ILLINOIS EPA RCRA CORRECTIVE ACTION CERTIFICATION

Additional Information requested by IEPA to Log No. B-43R-CA-109 PWY SEE – Response to 8/22/22 Letter & Final Design Report and Construction Work Plan

**Additional Information to Log No. B-43R-CA-109 (PWY SEE – Response to 8/22/22
Letter & Final Design Report and Construction Work Plan)
Roxana, Illinois
1191150002 – Madison County
Equilon Enterprises LLC d/b/a Shell Oil Products US
Log No. B-43R-CA-109**

EQUILON ENTERPRISES LLC DBA SHELL OIL PRODUCTS US FORMER PUBLIC WORKS YARD STEAM ENHANCED EXTRACTION ROXANA, ILLINOIS		PROJECT NO. 60697537
AECOM		
DRN. BY: bah Jan 2023 DSGN. BY: djd CHKD. BY: wmp	Benzene Plume >580 mg/kg with SEE System Layout and 1986 Release Location	FIG. NO. 4.a

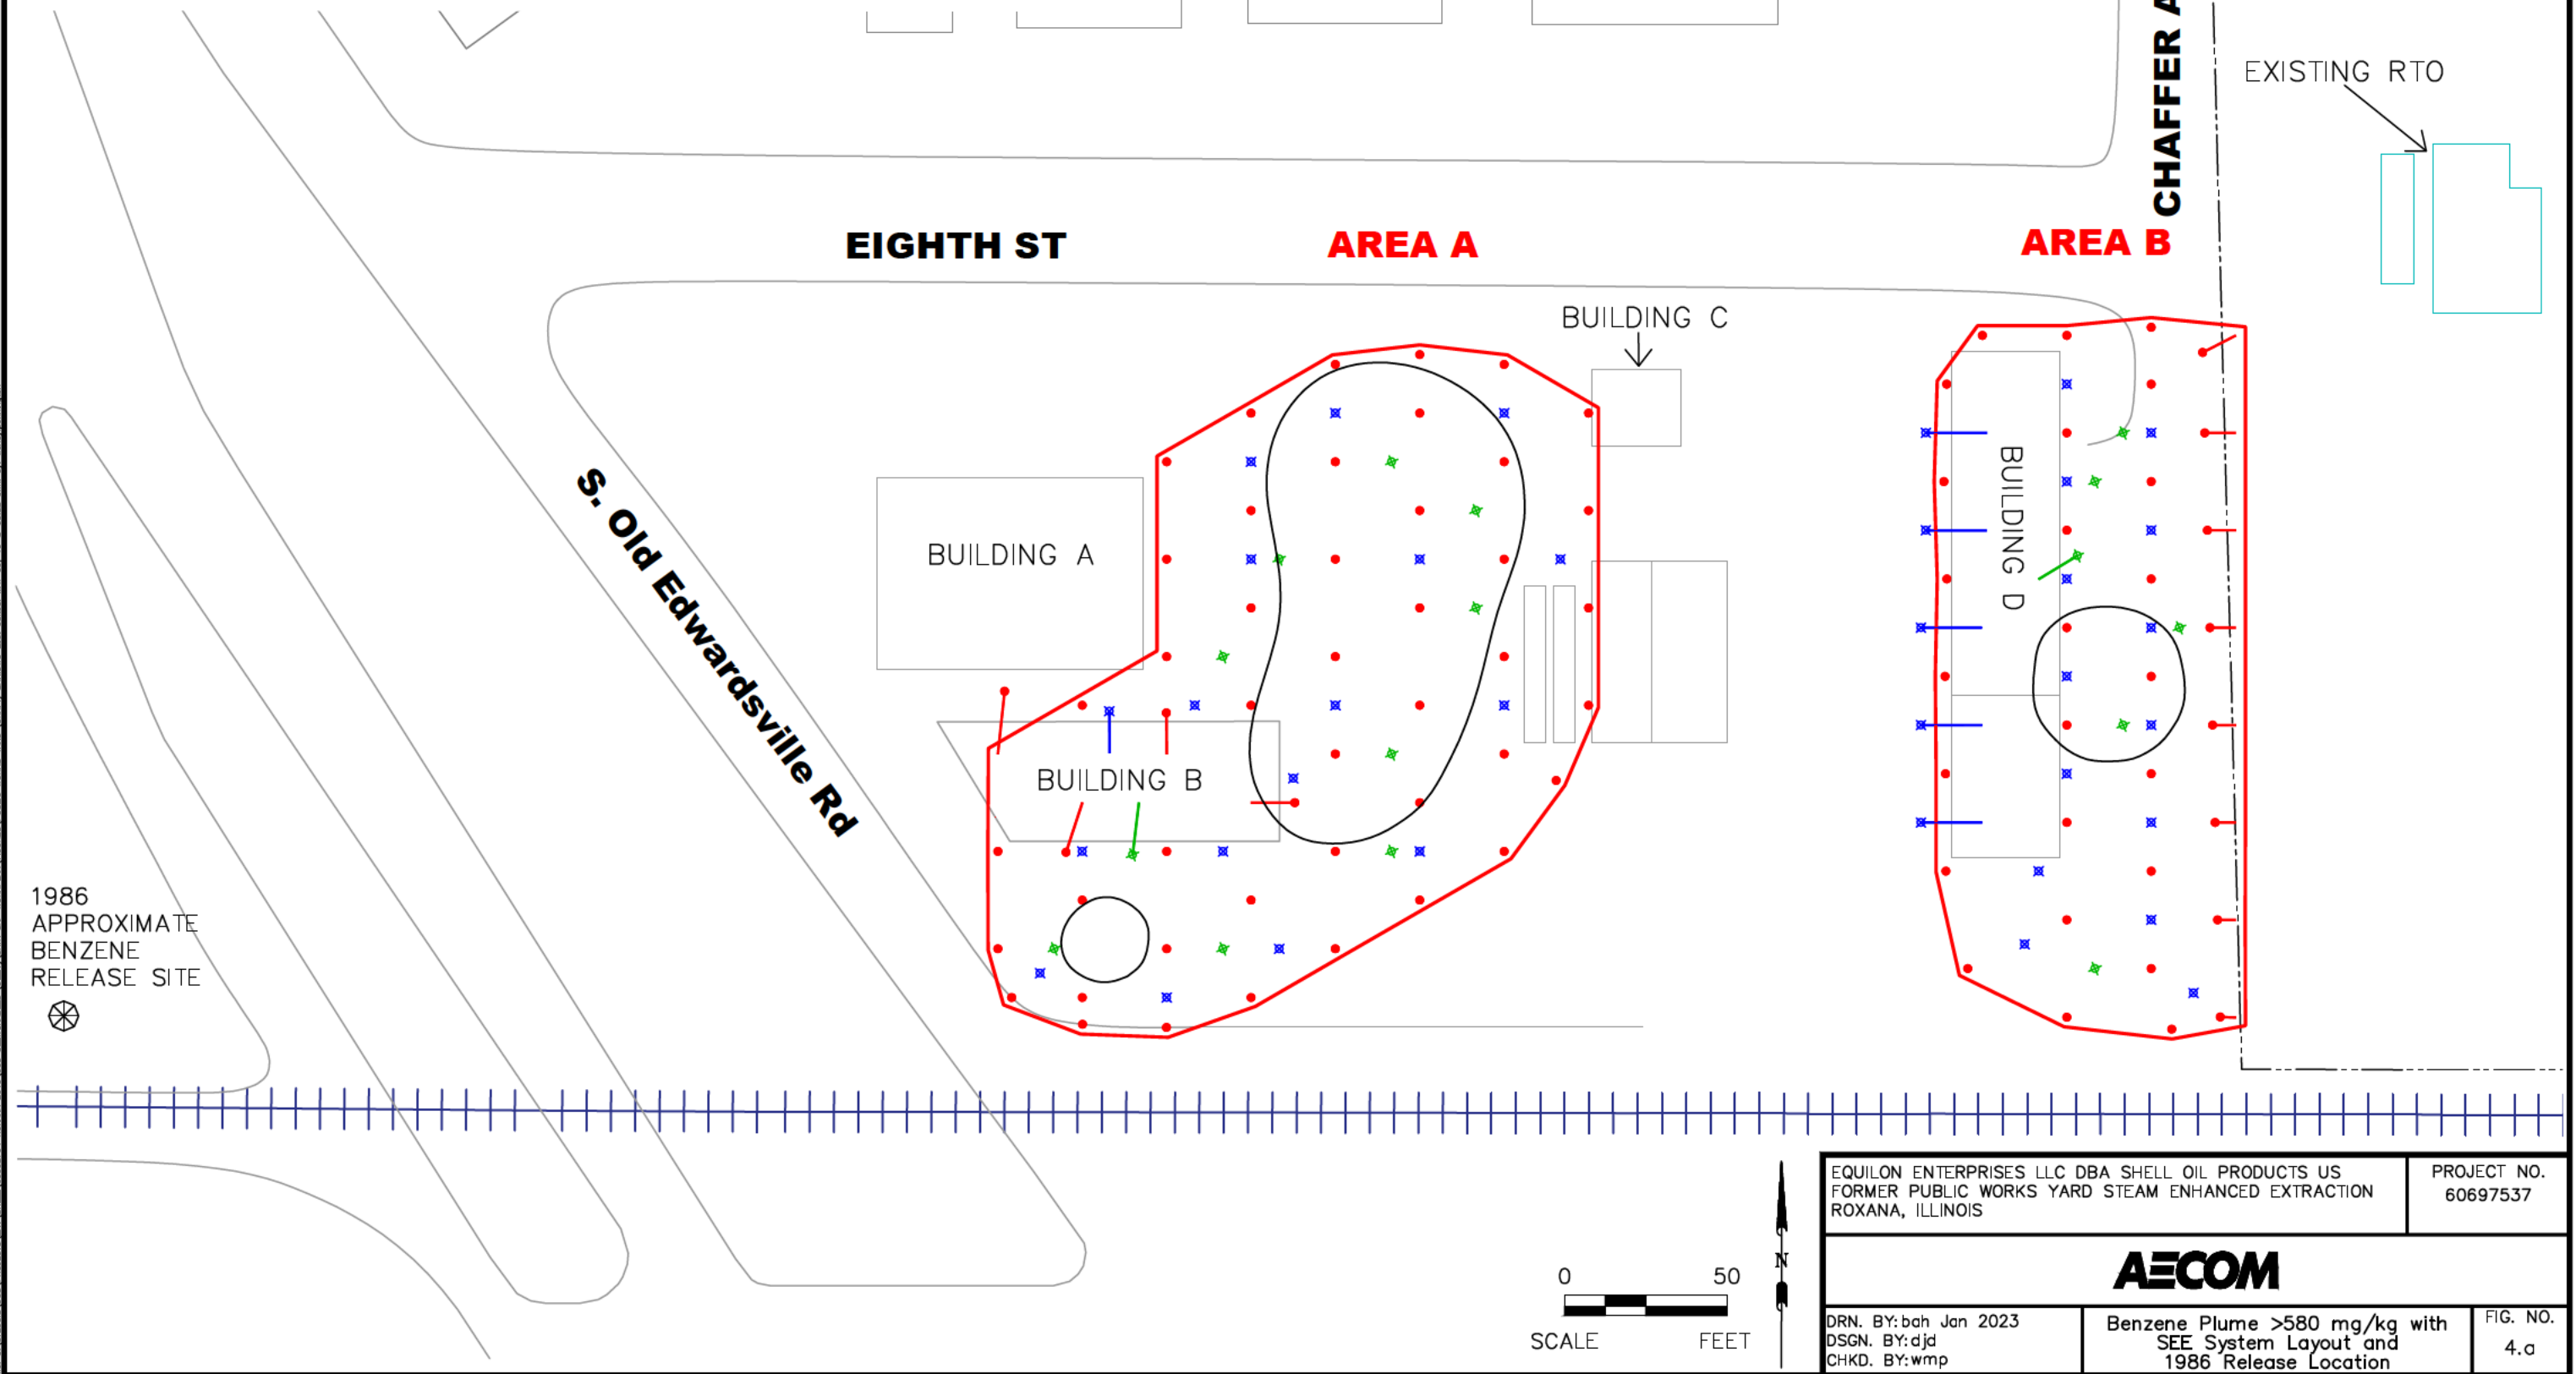
IEPA General Additional Request – Provide a figure showing the Former Public Works Yard layout and the approximate 1986 benzene release location.

Shell Additional Response – See **Figure 4.a**, enclosed, for the general system layout with the modeled benzene residual plume using a Csat value of 580 mg/kg and including the approximate 1986 benzene release location.

PUBLIC WORKS YARD PREDESIGN INVESTIGATION ROXANA, ILLINOIS		PROJECT NO. 60592794
AECOM		
DRN. BY: bah Oct 2019 DSGN. BY: djd CHKD. BY: jcb	Benzene Groundwater Analytical Results	FIG. NO. 9

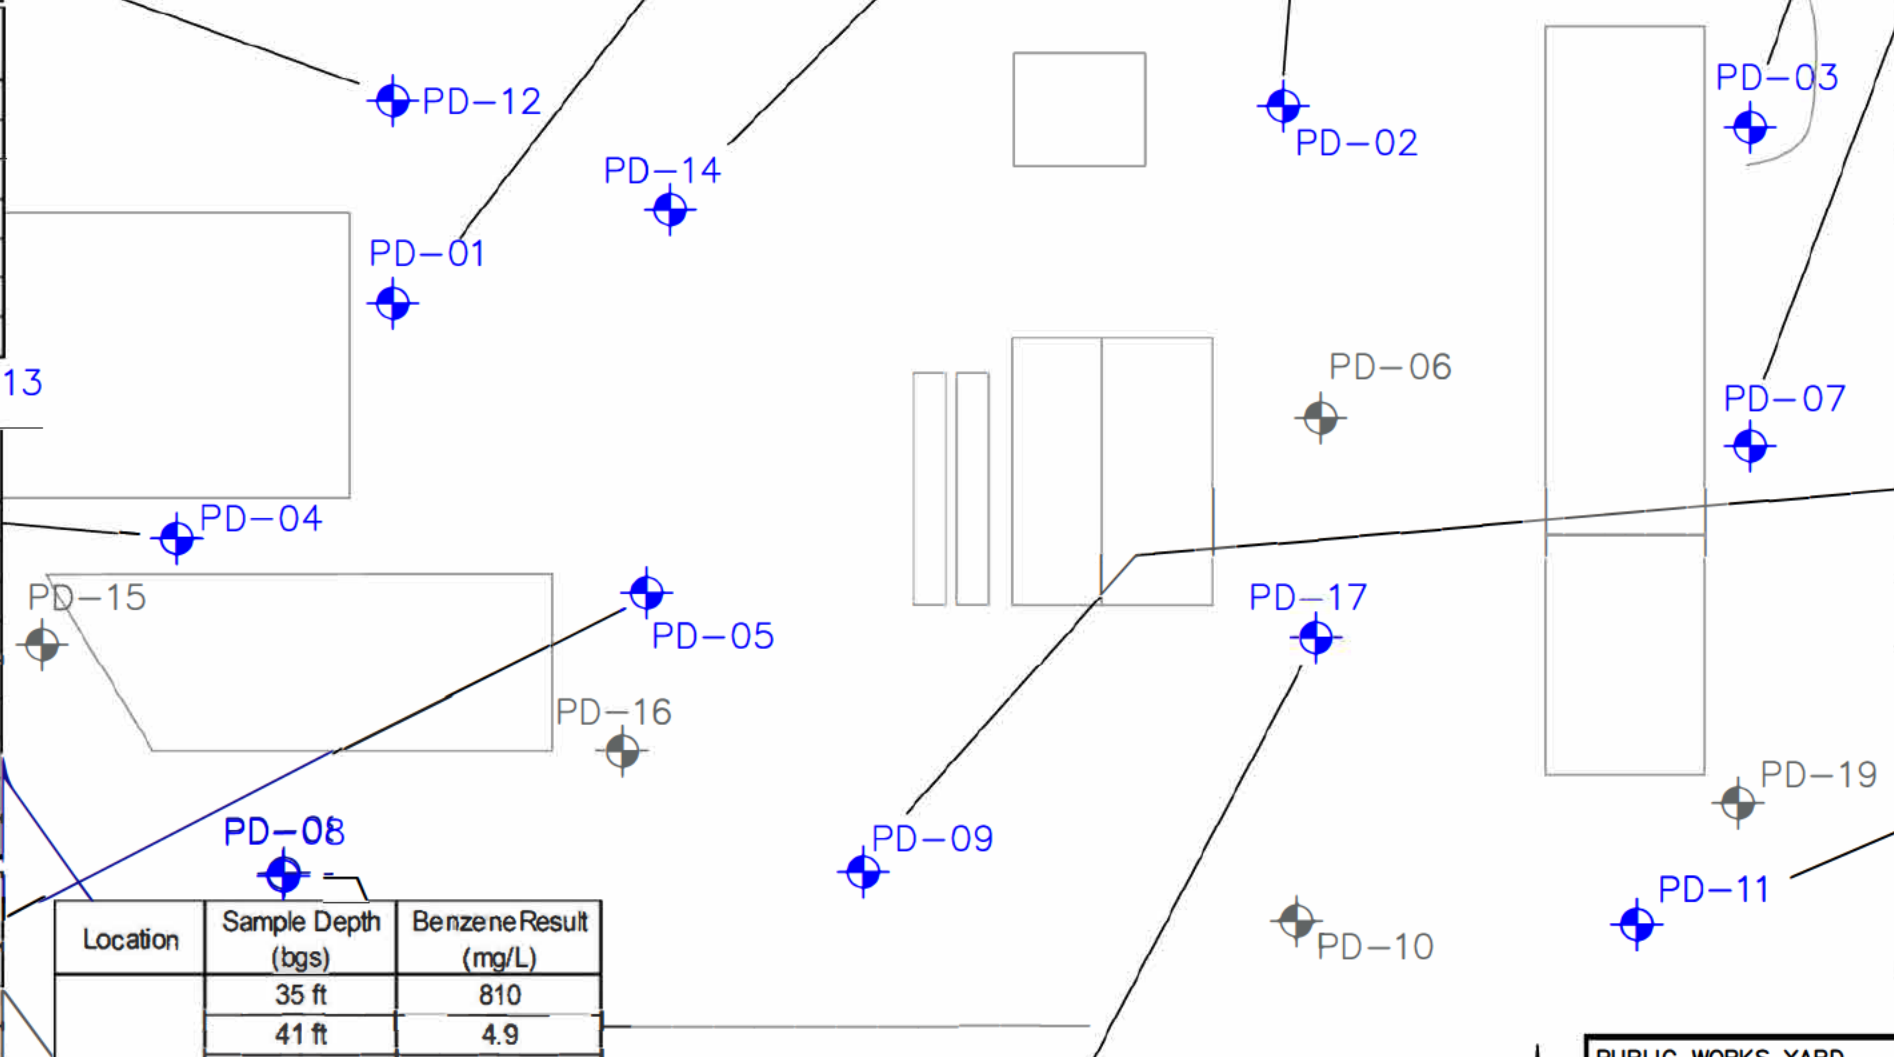
IEPA Original Condition 7.g – *Attachment A, Appendix H: No groundwater samples were collected at PD-06, PD-10, PD-15, or PD-16. However, PD-06-, PD-09, and PD-16 had a dyeLIF response. Therefore, new samples must be collected for groundwater delineation at PD-06, PD-09, and PD-16.*

IEPA Additional Request – Provide a figure showing the “PD” locations performed during the Pre-Design Investigation as well as the Pre-SEE drilling and sampling locations for ease of reference during submittal review. Provide additional information (including figures) regarding not proposing additional groundwater profiling at PD-16 at this time. In an email dated January 26, 2023, it was requested that Figure 5B from Attachment A (*Public Works Yard Predesign Investigation Report*) of the January 31, 2022, *Public Works Yard Steam Enhanced Extraction Work Plan* be updated to include all the data for the “GP” locations.

Figure 9 (Benzene Groundwater Analytical Results) from Attachment A (*Public Works Yard Predesign Investigation Report*) of the January 31, 2022, *Public Works Yard Steam Enhanced Extraction Work Plan* is enclosed as **Attachment K** and shows all the groundwater profiling benzene results from the 2019 investigation. Also included in **Attachment K** for purposes of completeness is Figure 8 (Benzene Soil Analytical Results) from the same attachment in the same Work Plan.
